# OVER-RUNNING ALTERNATOR PULLEY 59964

REPLACES 5 AND 6 GROOVE PULLIES

TECHNICAL INFO NO. 1116

**Image 1:** Left, RUVILLE over-running alternator pulley 59964 with 6 grooves – Right, over-running alternator pulley with 5 grooves

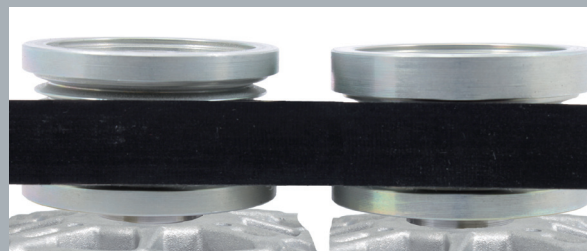
When positioning the V-ribbed belt with 5 grooves on the over-running alternator pulley with 6 grooves, it is essential to ensure that the outer groove is left free (image 1, left). This guarantees that the V-ribbed belt is aligned when it runs.

RUVILLE only offers the over-running alternator pulley with 6 grooves 59964 (image 2) for all models. This alternator pulley can also be used without any problems in alternators with a V-ribbed belt with 5 grooves.
